Staff Report

Re: Accessory Dwelling Unit – Conditional Use (PLNPCM2019-00312)

PROPERTY ADDRESS: 1978 S Windsor Street

WINDSOR STREET ADU 1978 Windsor Street Salt Lake City UT 84105

Proposed site plan

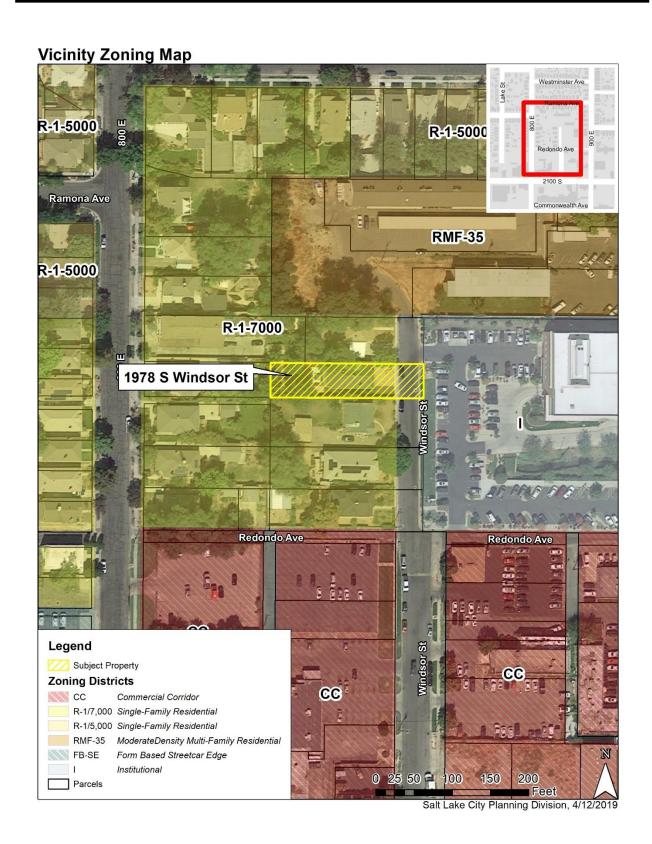
- Approval of Conditional use does not provide utilities permits or building permits.
- Submit complete building plans including a site development plan. Include existing and proposed utilities.
- Sewer lateral as show is not acceptable. Pressure lines are not allowed in the public way. Policy for ejector pumps is that at least one level must gravity drain to the sanitary sewer.
- Ejector pump should pump to a manhole or cleanout on property and then gravity drain to the public system.
- Sewer laterals must be 10' from water services, meters or laterals and 5' from all other utilities.
